SHOREHAM NUCLEAR POWER STATION

SNRC-450

Shoreham Nuclear Power Station - Unit 1
Docket No. 50-322

Enclosed herewith are six (6) sets of Shoreham-specific system information in response to those Bulletins and Orders Task Force long-term questions of July 13, 1979. These responses will be incorporated in a pending supplement to the generic data presented in NEDO-24708, "Additional Information Required for NRC Staff Generic Report on Boiling Water Reactors."

FIGURE A

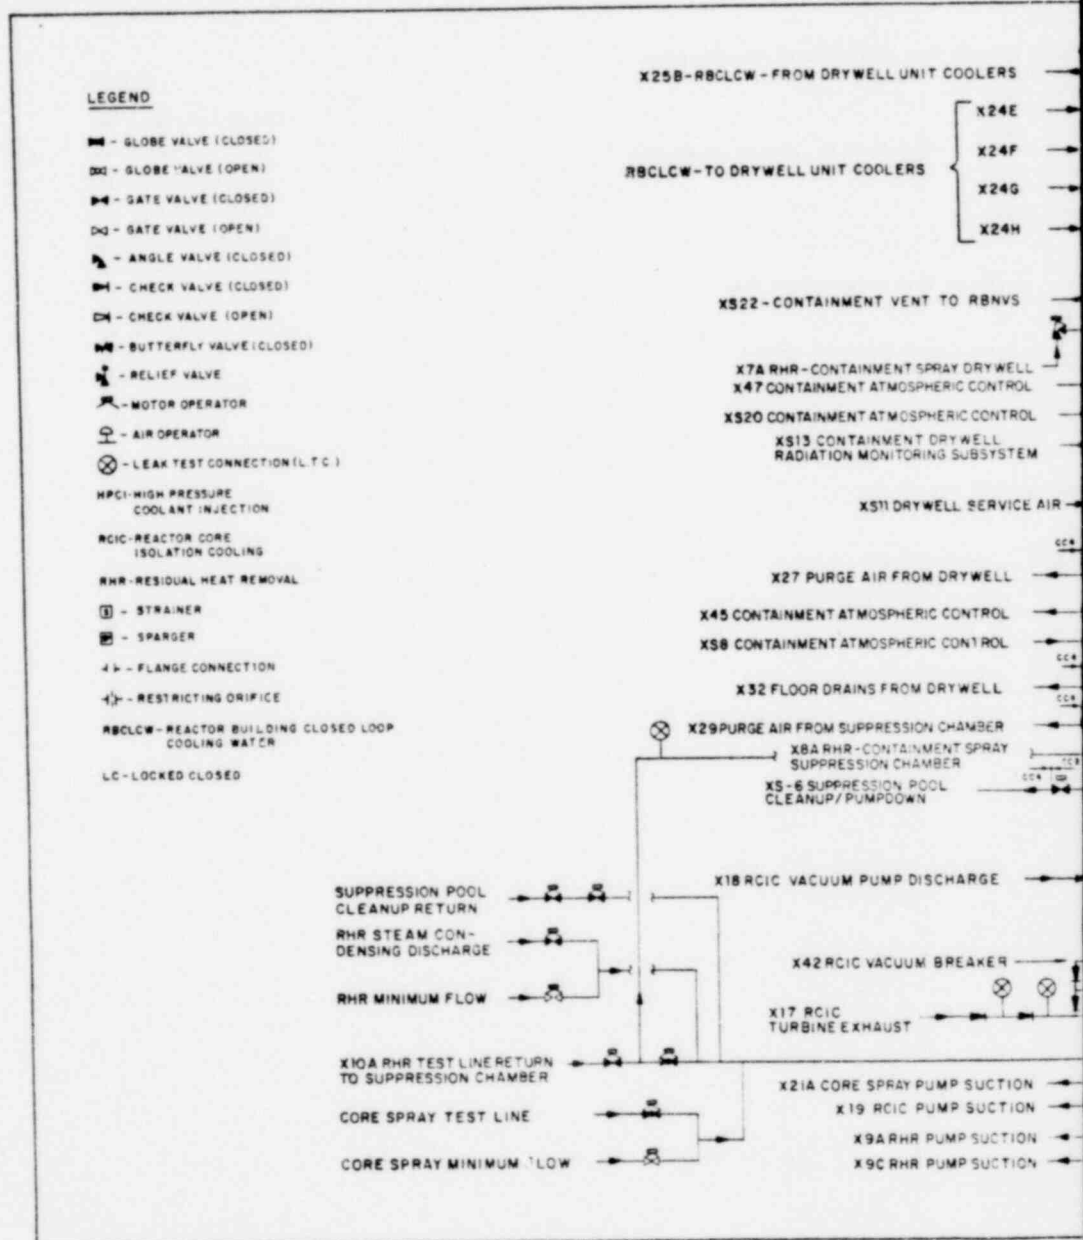
Response: In general, Reactor Coolant Pressure Boundary Containment Isolation Valves (Figure A) can be tested for operability by stroking the valves (one at a time) during normal plant operation. This testing is accomplished by remote manual operation. The following exceptions to this general rule apply:

1. X5 - RHR Shutdown Cooling Line from RPV

Containment isolation valves in this line are normally shut, and cannot be opened with the RPV at full pressure. Operability may be demonstrated at any time, provided steam dome pressure is less than 135 psig.

2. Simple Check Valves Associated with X2A&B, X-36, F-10, and F-11

Inboard main feed water check valves may be demonstrated to shut on reverse flow when the reactor is shut down and feedwater is secured. Standby Liquid Control check valves may be demonstrated to shut on reverse flow at any time, by means of opening upstream test connections. Recirculation Pump Seal Injection check valves may be demonstrated to shut on reverse flow when the reactor is shut down, recirculation pumps are secured, and seal injection is secured.

PLANT SHOREHAM UNIT 1
 FIGURE B
 CRITERION 56 CONTAINMENT
 ISOLATION VALVES

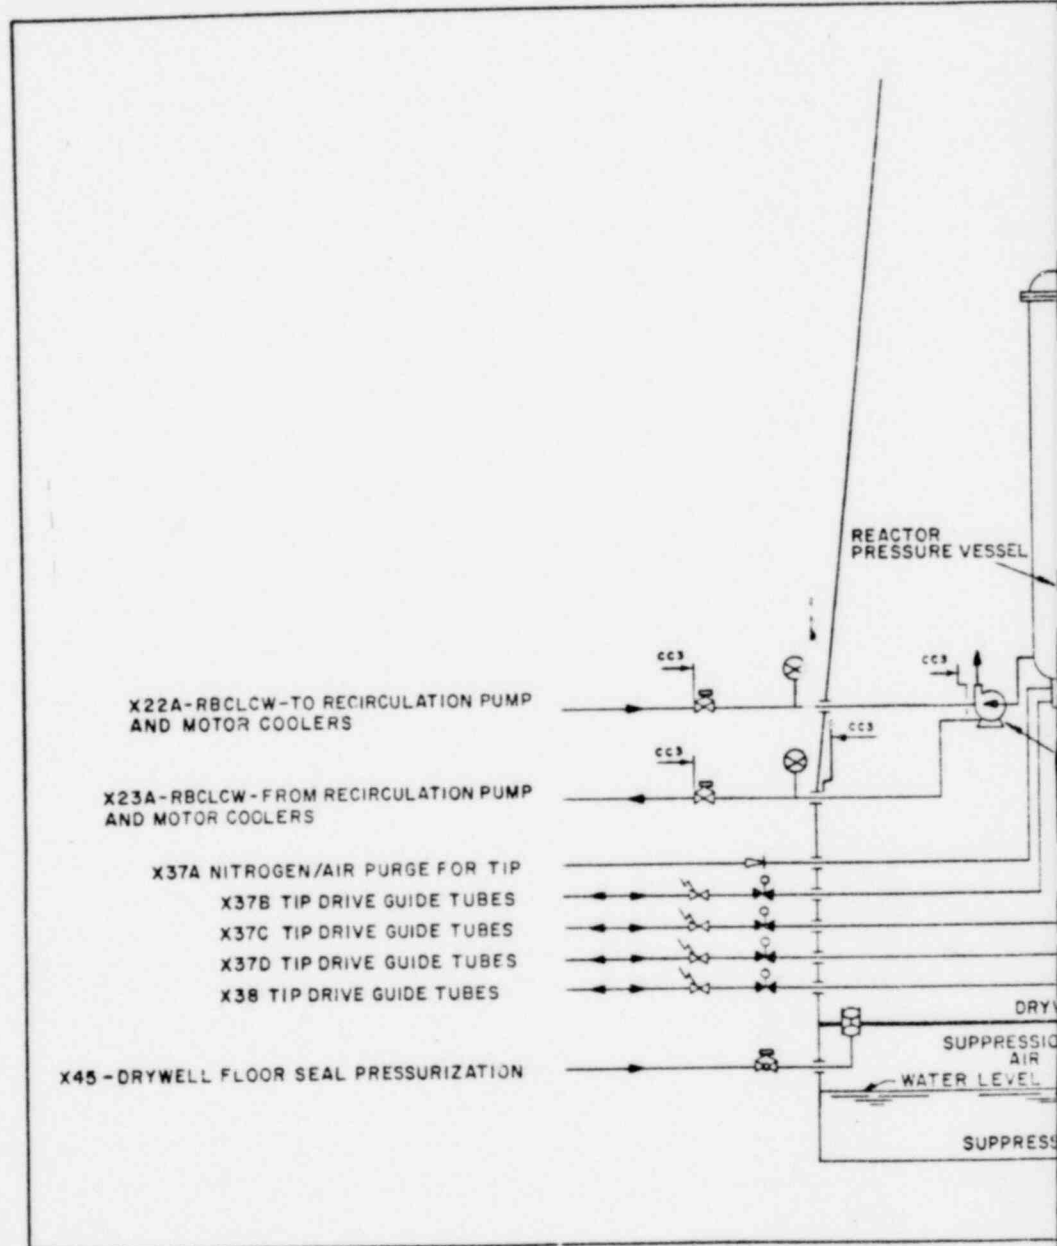
With the following exceptions, the balance of the containment isolation valves (Figures B & C) may be tested for operability at any time by means of remote manual stroking of the valve:

1. Figure B Containment Isolation Check Valves may be demonstrated to shut on reverse flow during integrated containment leak rate testing. Inboard RBCLCW check valves may be tested when shutdown using vent and test connections.
2. TIP Drive Guide Tube Explosive Valves (X37B, C, D, & X38) may be tested with the TIP's withdrawn. However, there is no intention to perform this test.
3. TIP Purge Check Valve (X37A) is tested for operability during containment integrated leak rate testing by exposing the valves to containment pressure via two-way equalizing valves on the TIP indexer units.
4. Figure B Relief Valves may be demonstrated to be seated for containment isolation during containment integrated leak rate testing.
